Addendum # 2

Bid Opportunity: 25-7639-RFT - Alpine Public School HVAC Upgrade

RE: Alpine Public School – HVAC Upgrade
Kitchener, ON

ADDENDUM 01

A-TRANSFORMER BASE DETAIL
SCALE: NTS

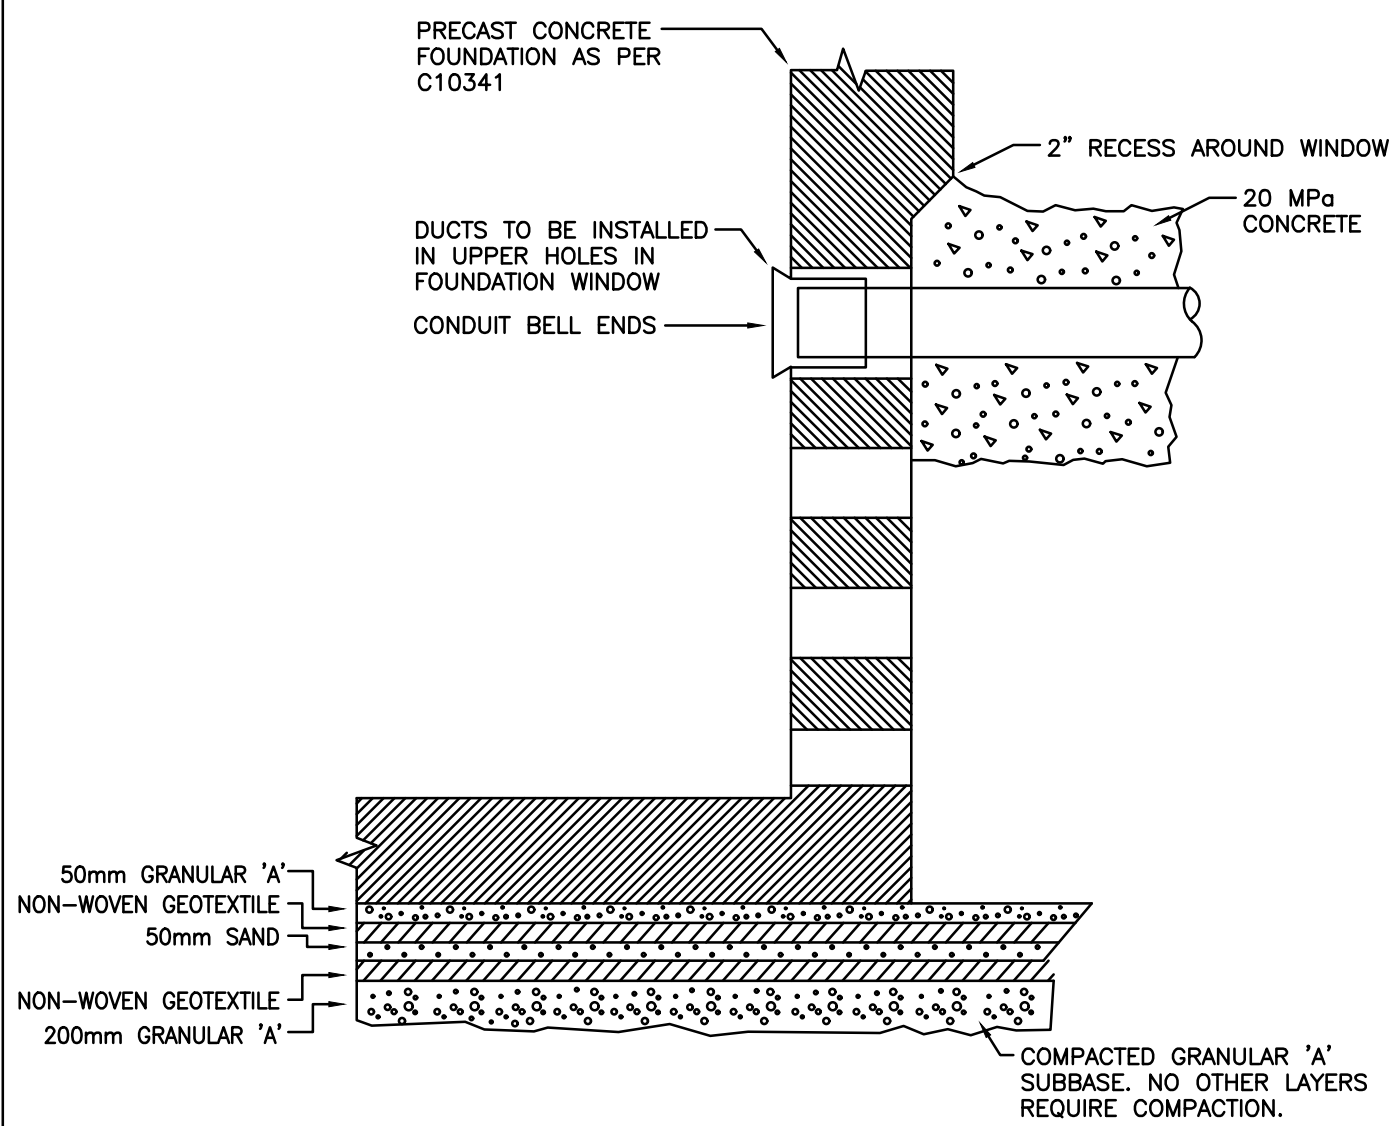
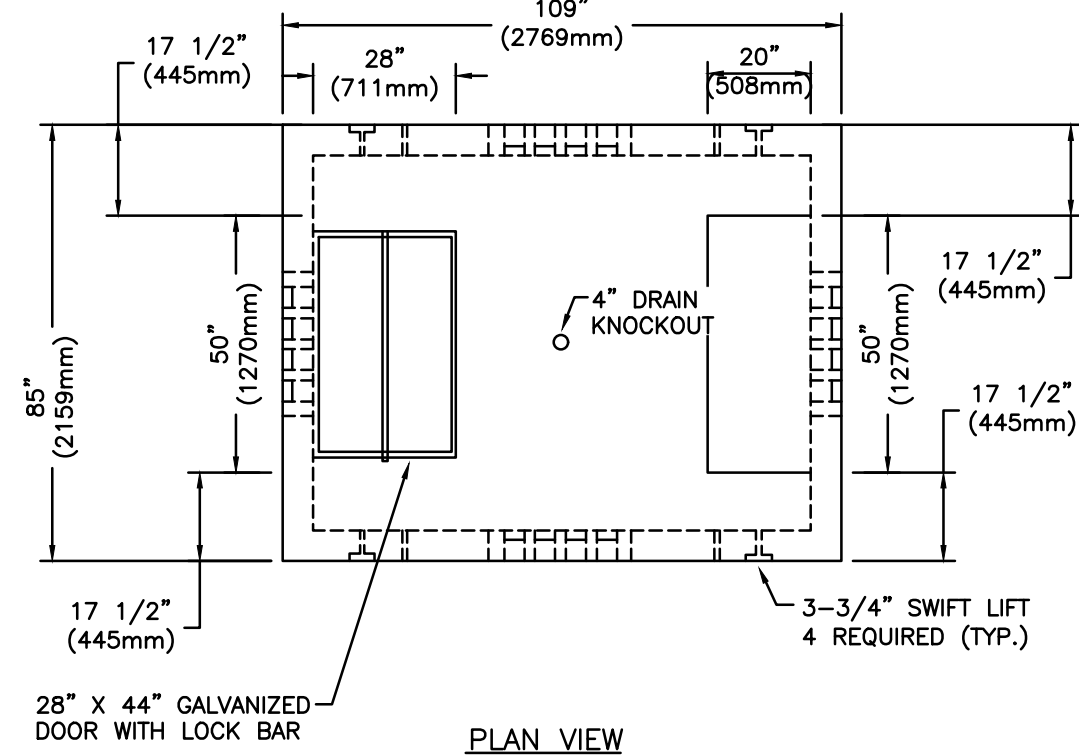
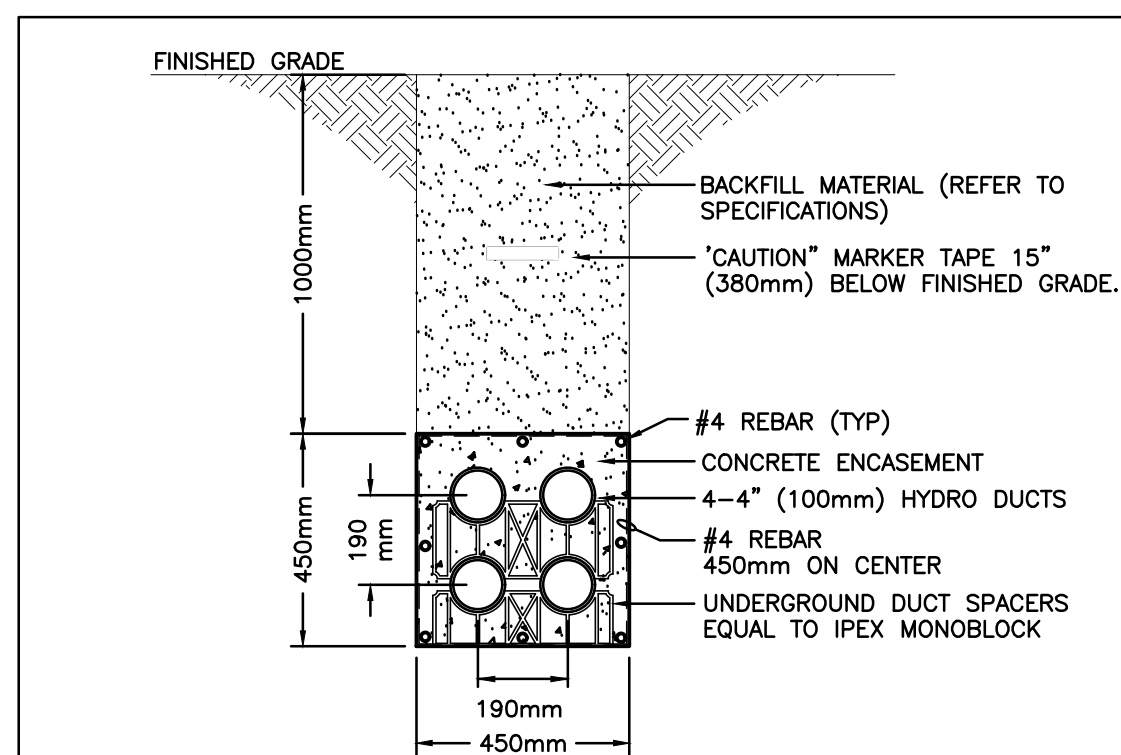
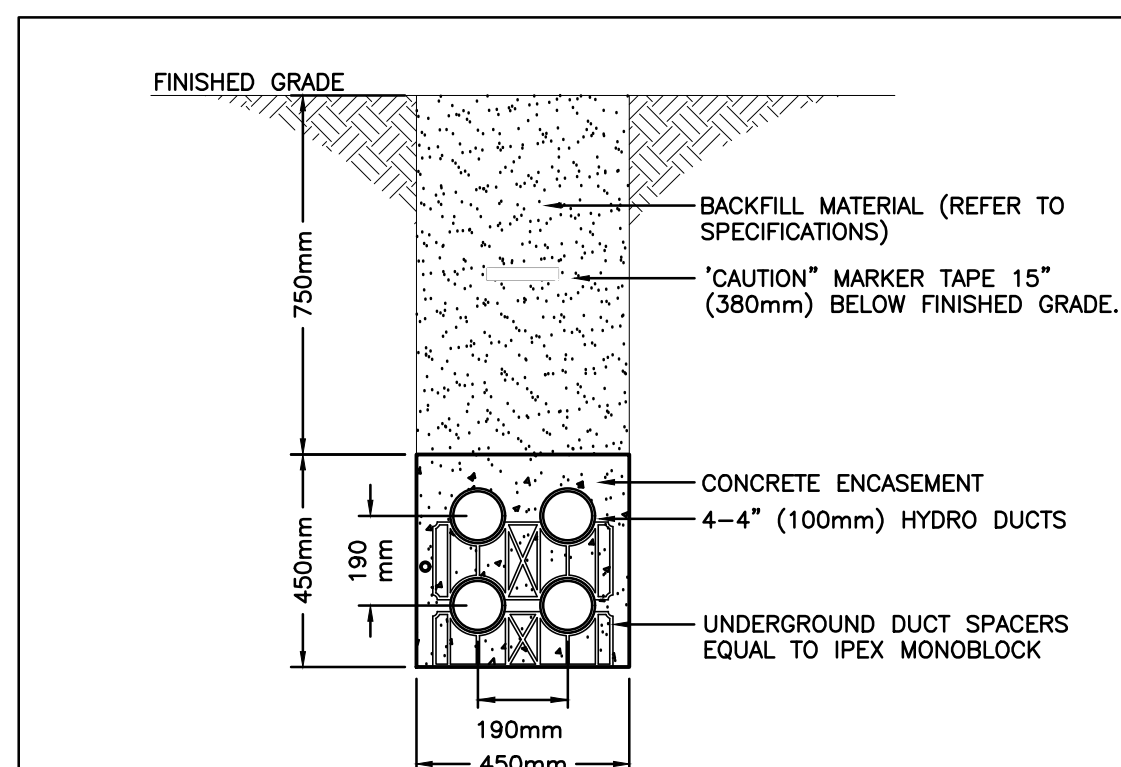
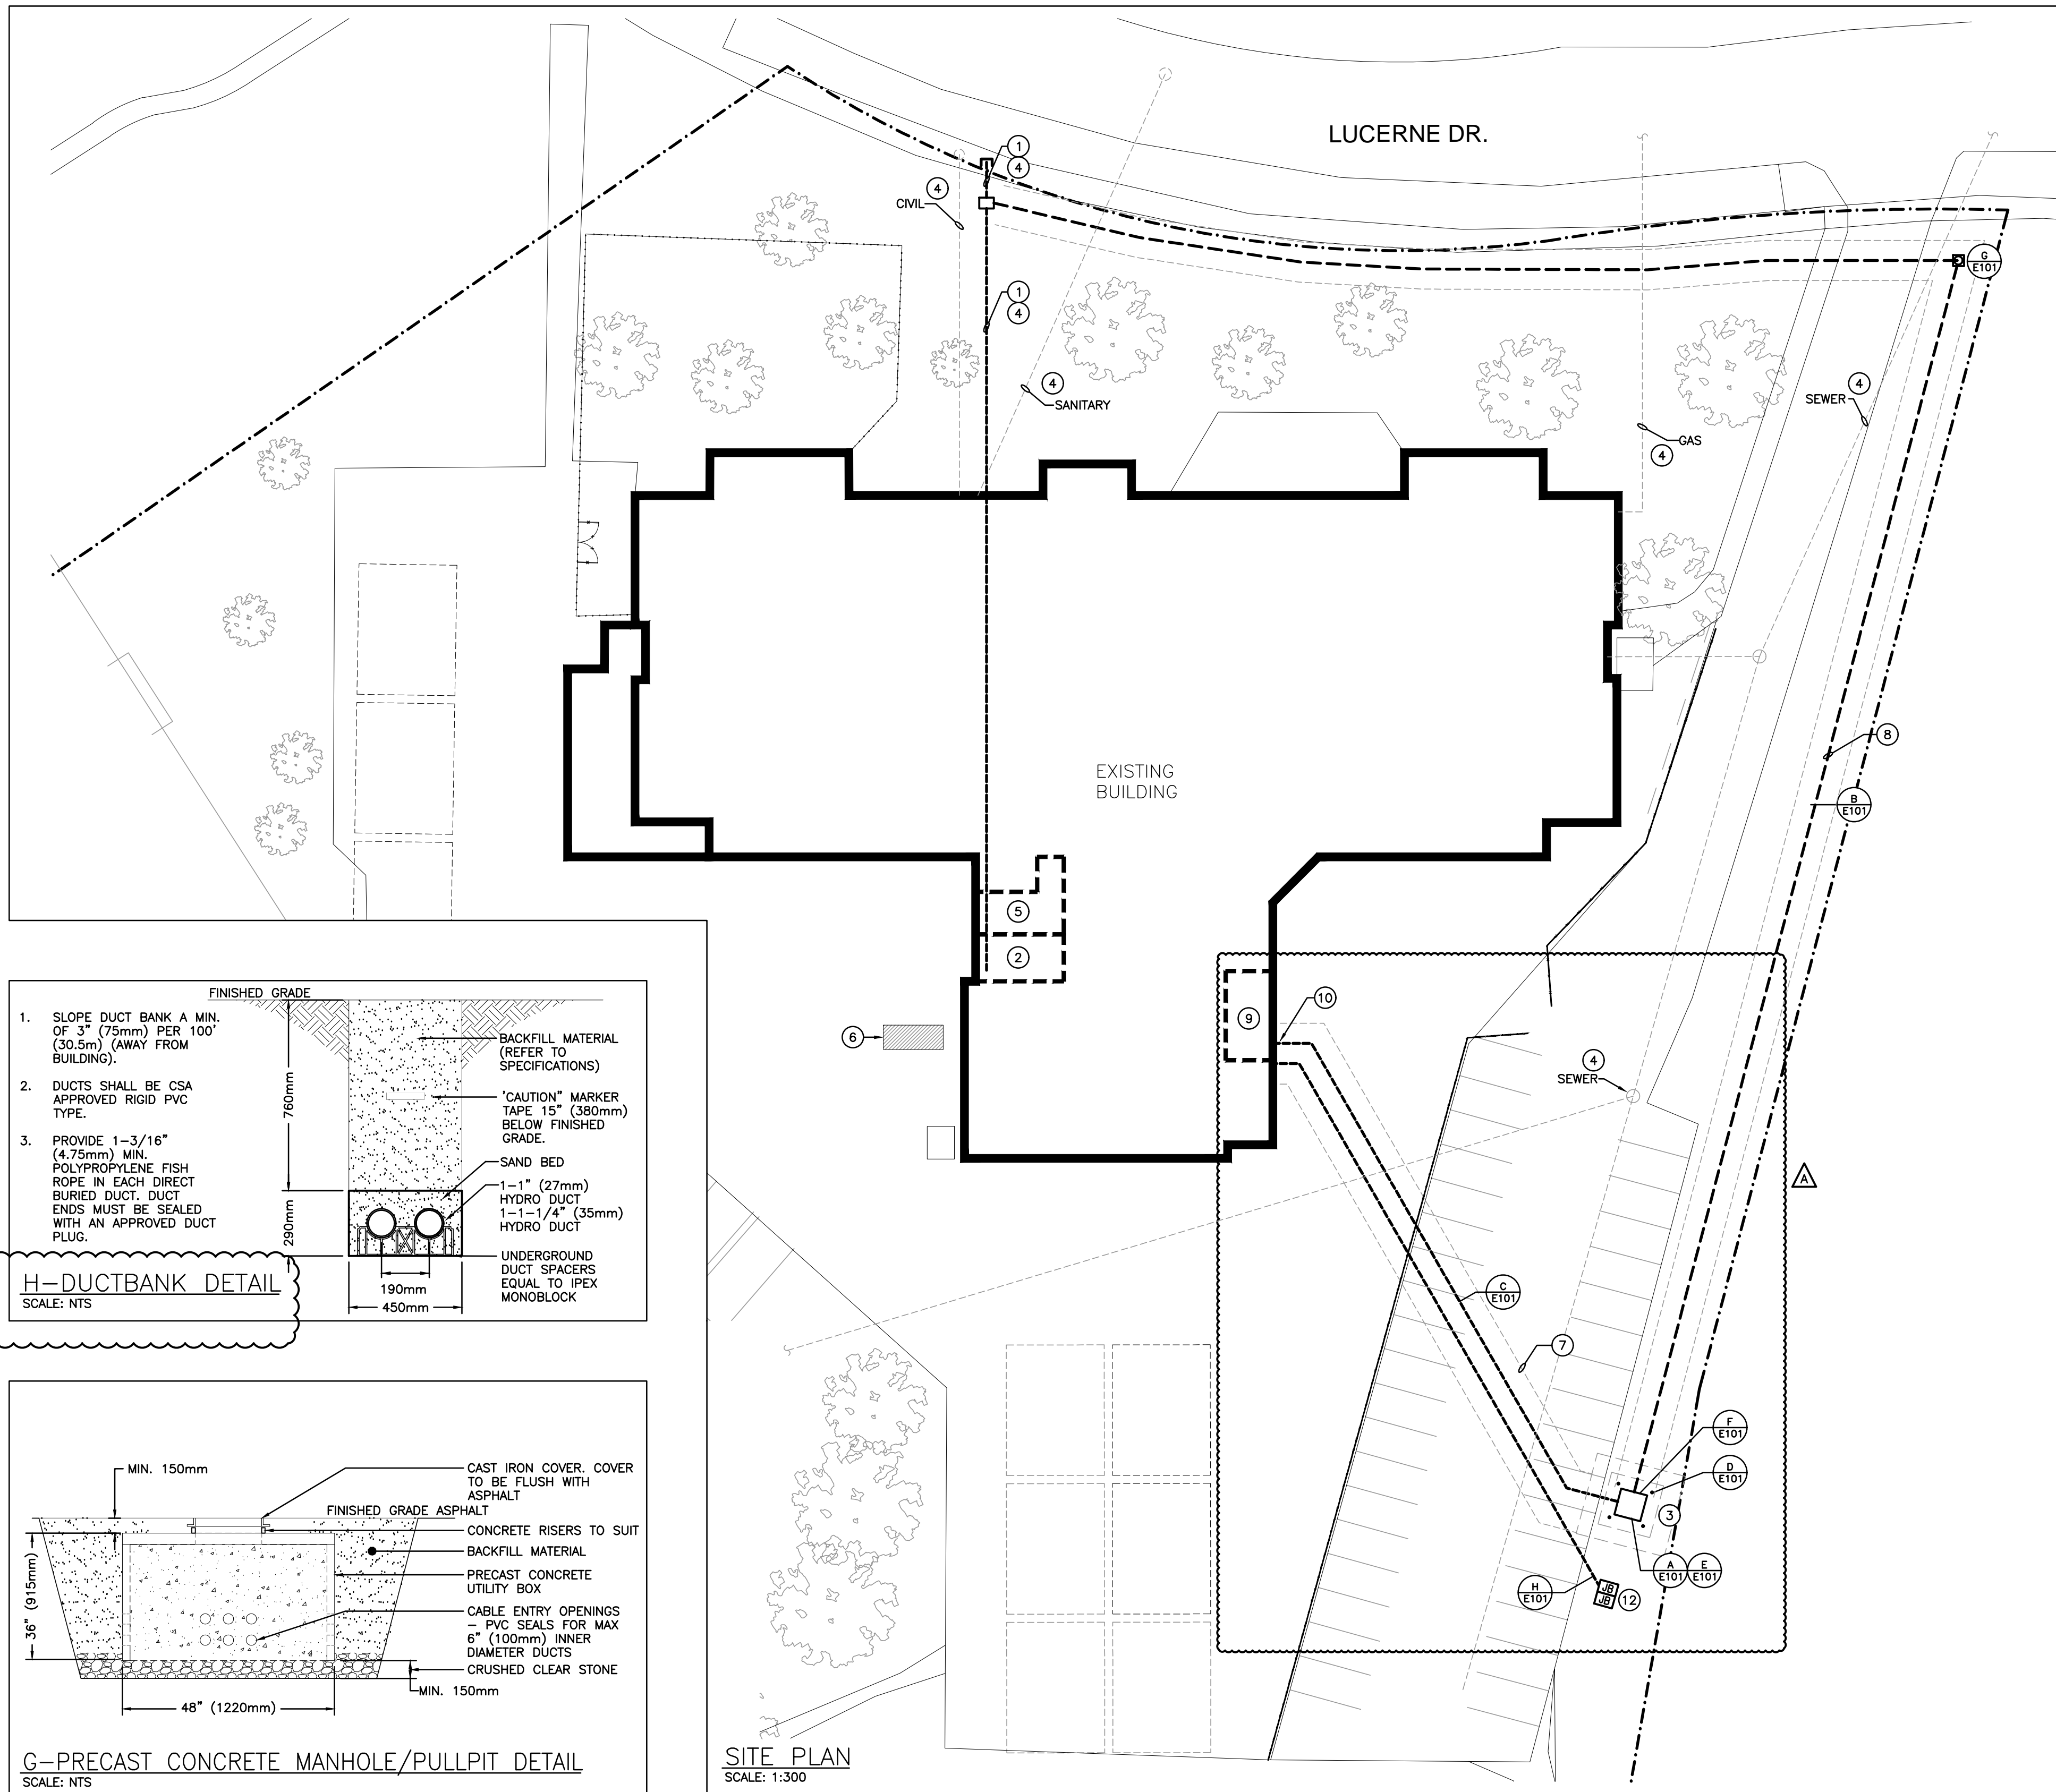
Item 2**2.0 Reference Attached Reissued Drawing E101**

- .1 Reference reissued drawings for approximate locations of existing underground infrastructure.
- .2 Contractor to provide one (1) 1" spare duct for future parking lot lighting upgrade and one (1) 1-1/4" spare duct for future EV charging station(s). Refer to reissued drawings for additional information.
- .3 Details for rental generator added.
- .4 No utility cash allowance required, all utility costs by owner, all coordination by contractor.

Transformer vault information on detail E/E101. All requirements are to be coordinated with Enova.
